SERVICE BULLETIN

No. 389

Piper Aircraft Corporation

Subject: Bridle Cable and Bridle Cable Clamp Inspection; AltiMatic V and AltiMatic V Flight Director Series Automatic Flight Control Systems

TYPICAL BRIDLE CABLE INSTALLATION
(PA-31 Series Roll Servo Shown)

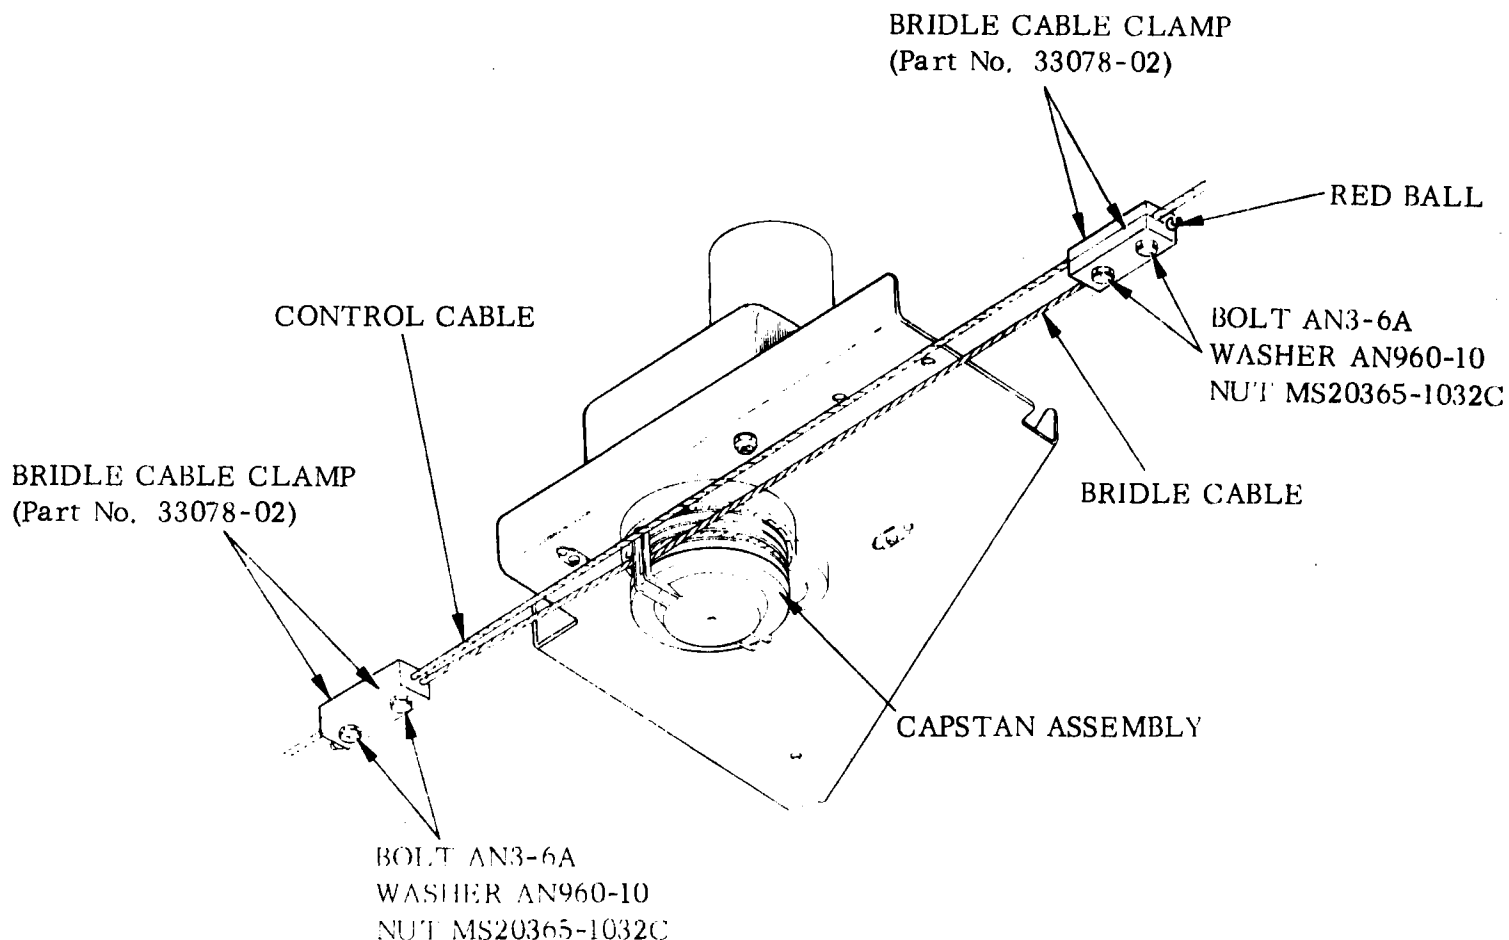
Purpose: Two reports have been received which described the slippage of the roll servo bridle cable clamps on the above referenced aircraft. It appears possible that the lock nuts used in the bridle cable clamp assemblies may have loosened, causing subsequent bridle cable clamp slippage. This condition can normally be prevented by routine inspections of the Automatic Flight Control System components as specified in the appropriate Piper periodic inspection forms, airplane service manuals and appropriate Automatic Flight Control System service manuals.

V SERIES AUTOPILOT BRIDLE CABLE AND BRIDLE CABLE CLAMP INSTALLATION AND SECURITY INSPECTION

1. Refer to the AltiMatic V and AltiMatic V-1 Service Manual (P/N 761 525) or the AltiMatic V F/D and AltiMatic V F/D-1 Service Manual (P/N 761 526) to gain access to the Roll and/or Pitch Servo Capstan Assembly.

2. Loosen the nuts on the bridle cable clamps - one at a time, then retighten; ascertain that the MS20365-1032C nuts retain their self-locking capabilities. If the nuts run freely on the AN3-6A bolts, replace nuts as required.

3. Check the control cable and bridle cable tension in accordance with the Roll and/or Pitch Servo Capstan Assembly Installation Instructions in the appropriate V Series Service Manual.

4. Torque the bridle cable clamp bolts to 23 ± 2 inch-pounds, above the nut running torque.
5. Check for proper position and security of bridle cable clamps and for proper servo function as outlined in the roll and/or pitch servo installation instruction in the appropriate V Series service manual.

6. Install all carpet, seats and panels previously removed and secure.
